WORKSHOP AGENDA

Planning Commission

August 13, 2024 @ 5:30 PM

Item #: 5. Item Title: Site Plan – Chipotle Mexican Grill – New Building of 2,300 Square Feet on 0.93 Acres. Requested by DSG. Property located at Murfreesboro Road & Veterans Memorial Parkway (Tax Map 14, Parcel 72.15). C-2 (Highway Service) Zoning District. Property owned by Woodhaven La Vergne, LLC.

DRAWING SCALE 20 0 20 40 SCALE: 1"=20'		
CES-3.0 CONCEPT PLAN

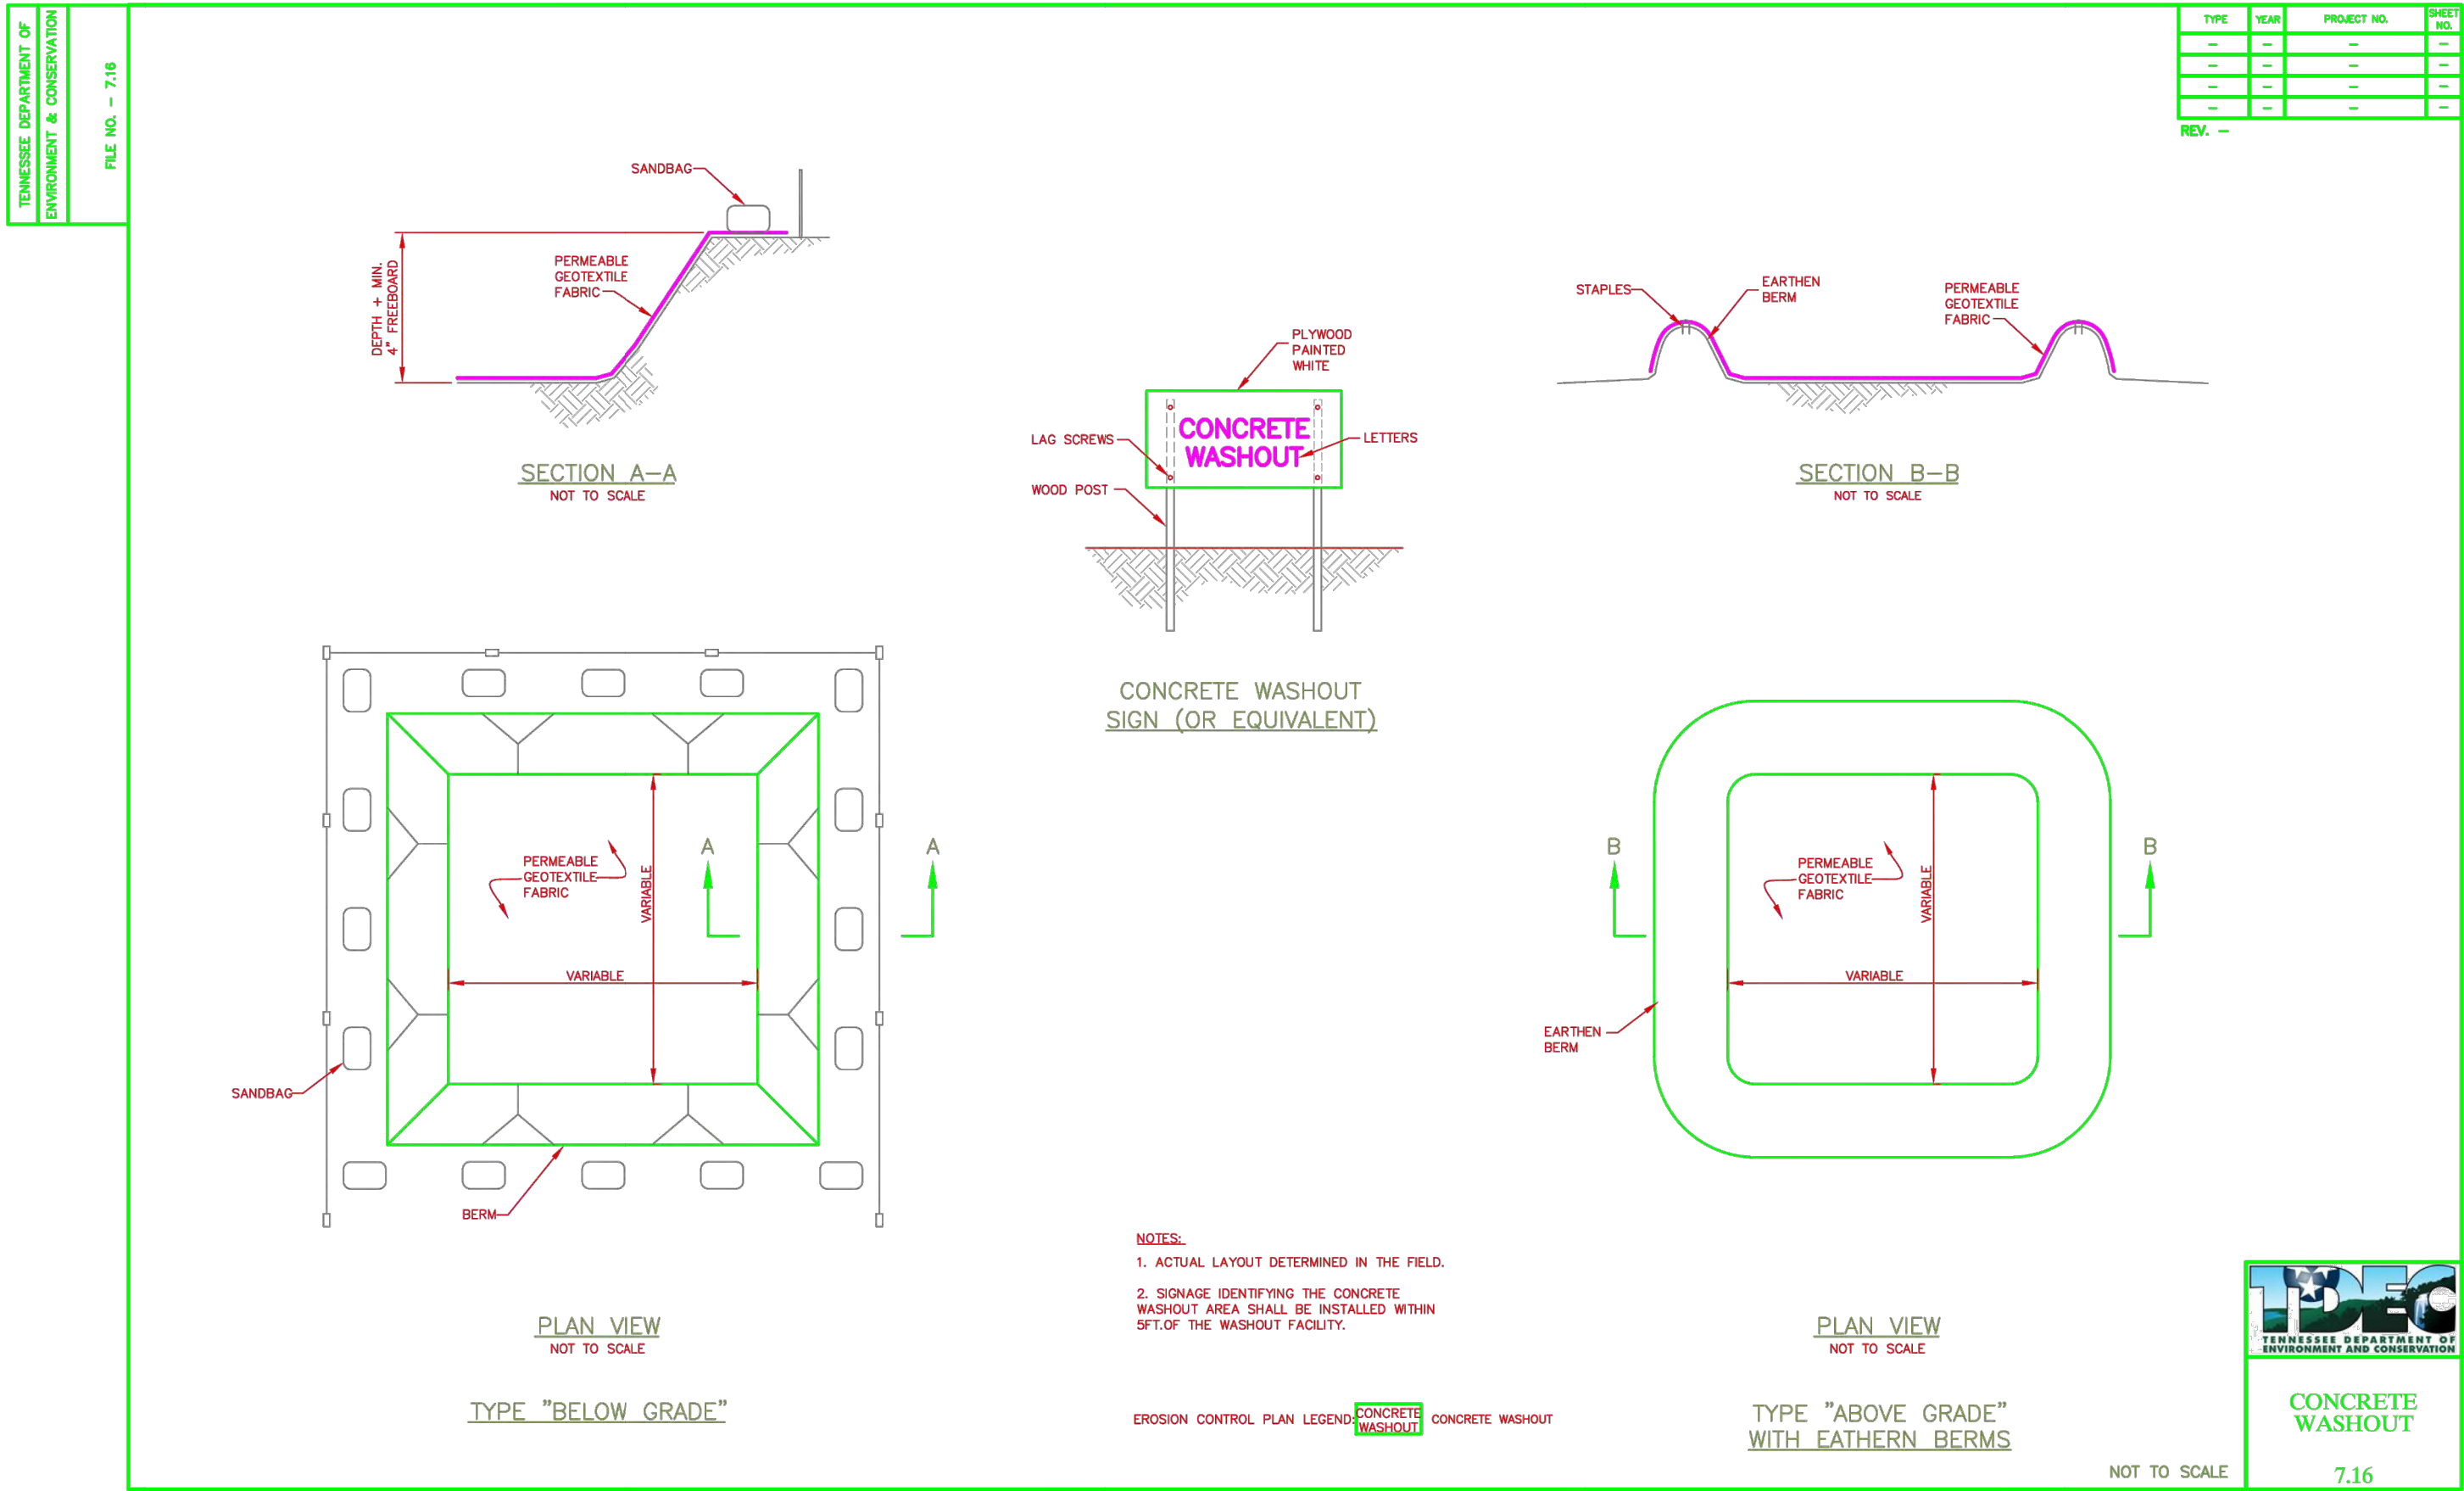
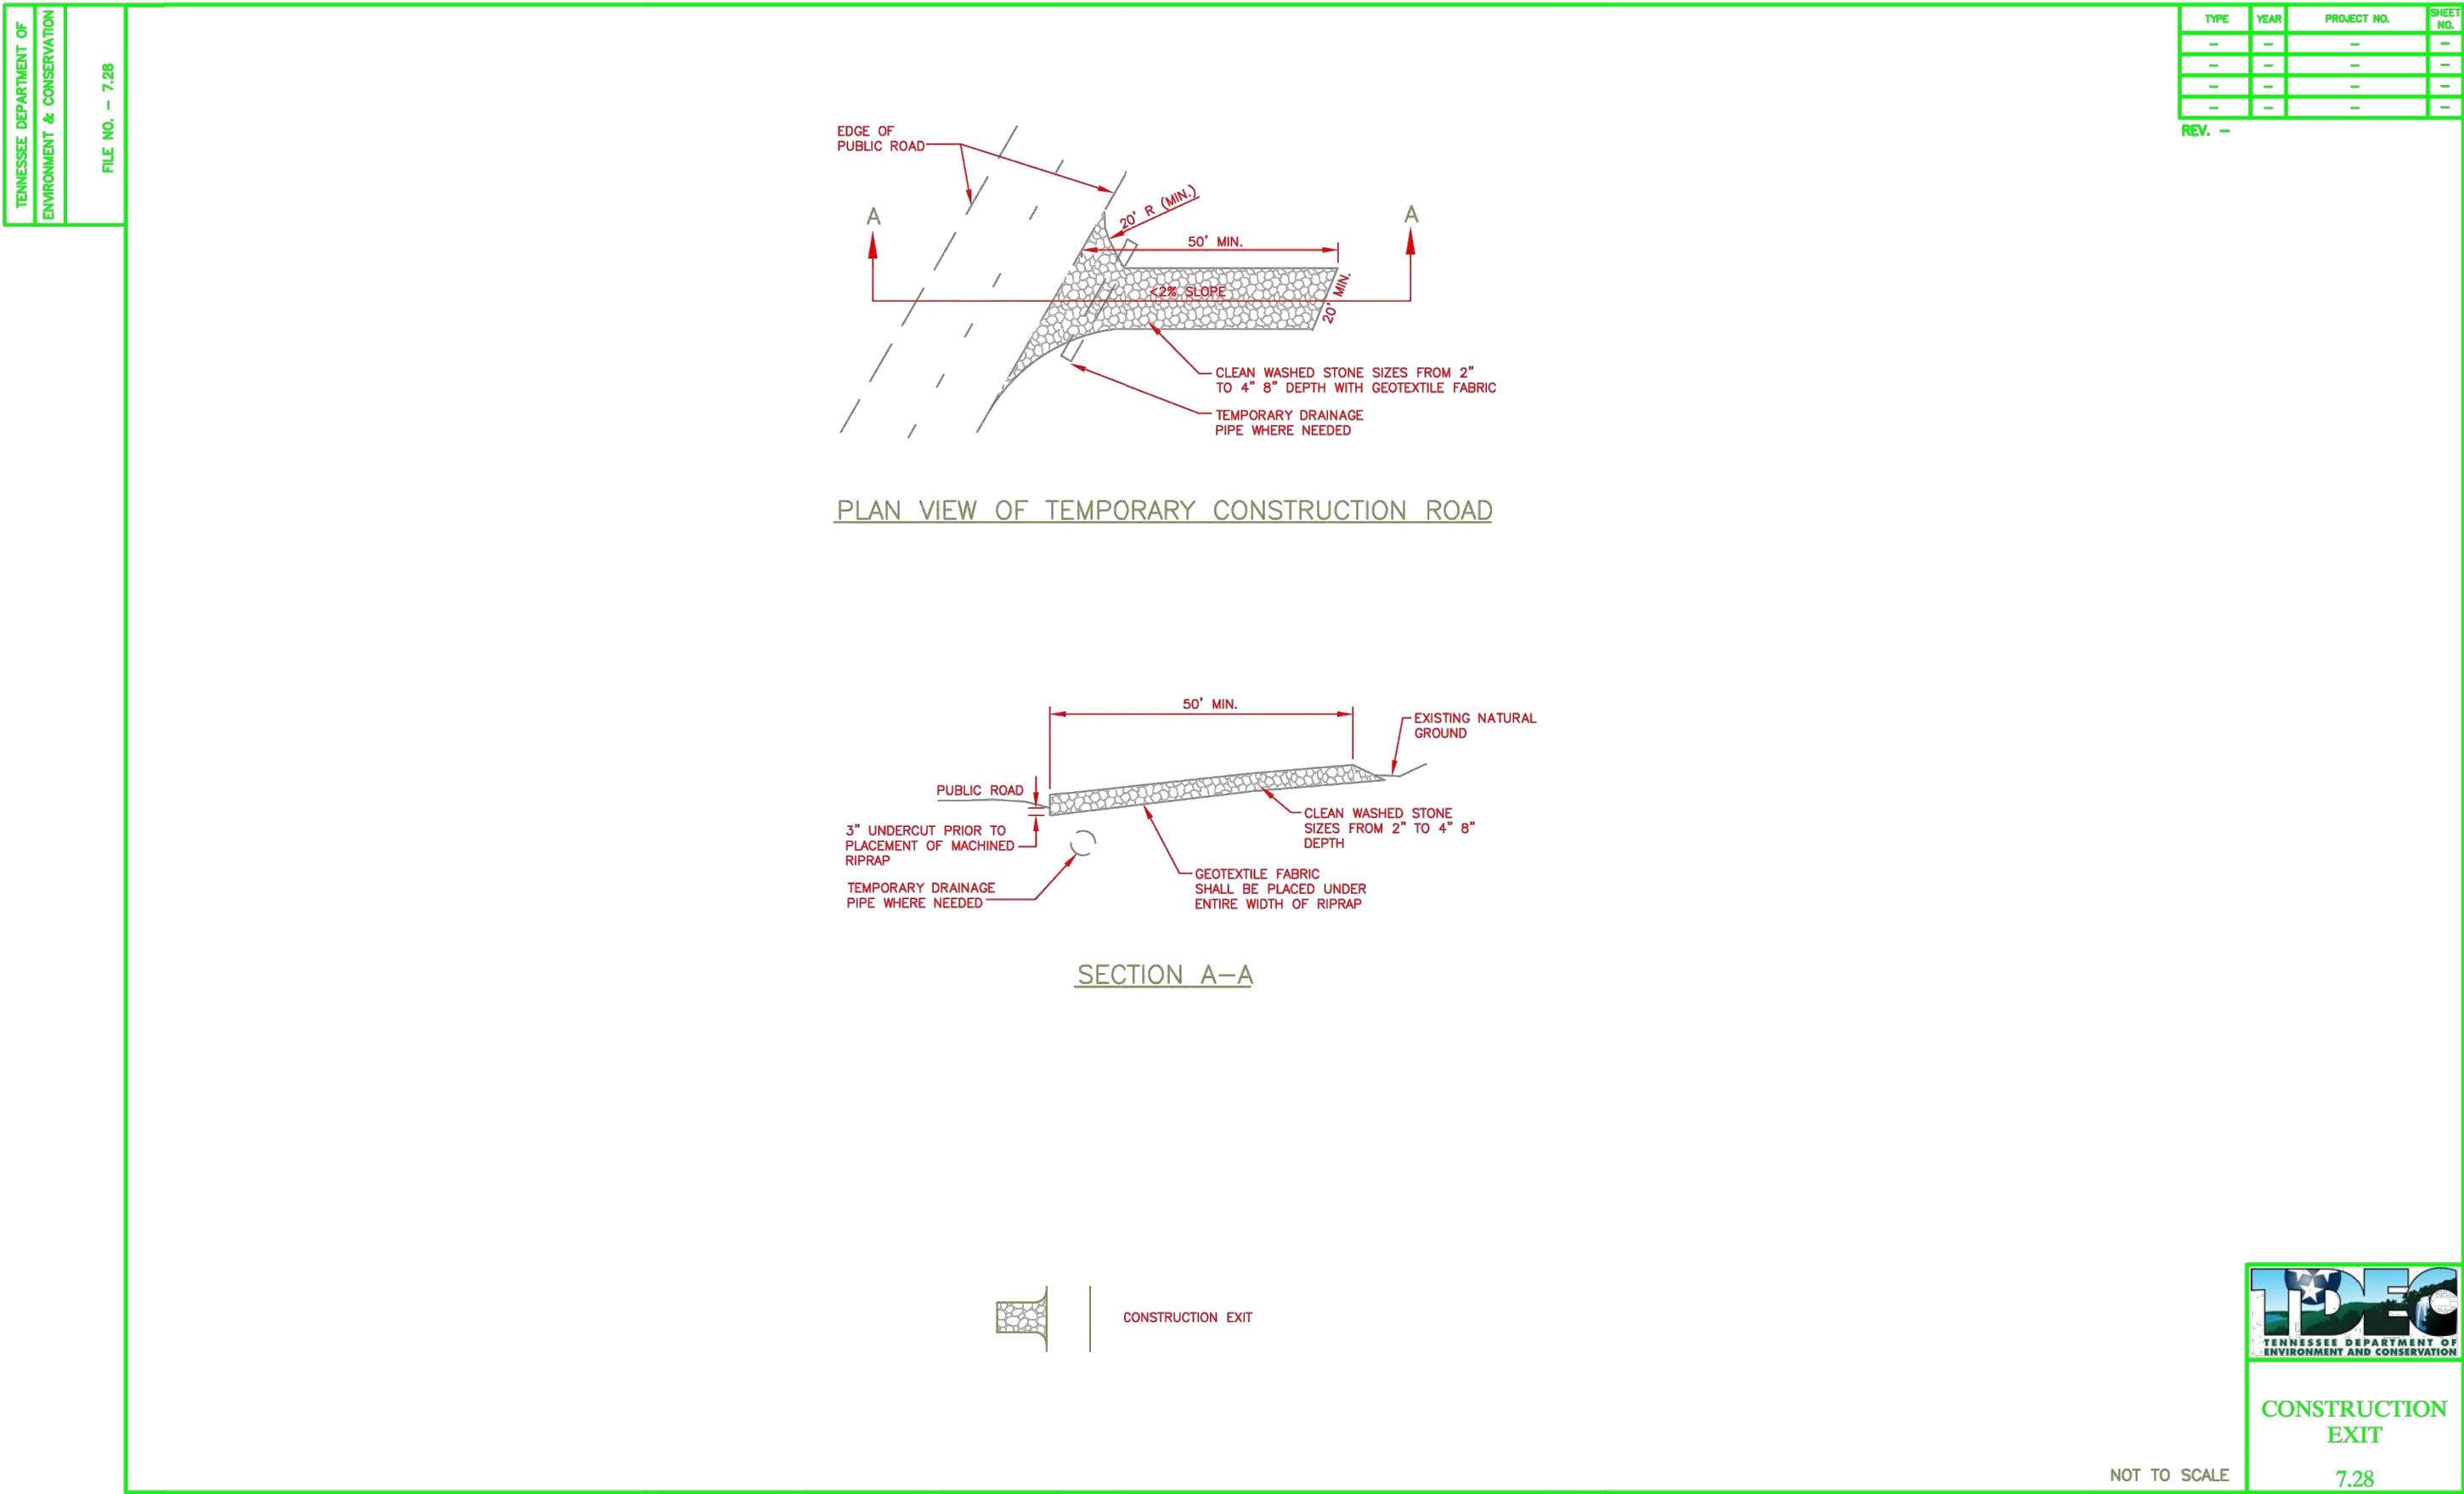
8. (Sheet CES-3.0) Show construction entrance on initial erosion control plan rather than intermediate. It will be required for initial inspection.
9. (Sheet CES-3.0) Show location of SWPPP box on initial erosion control plan.
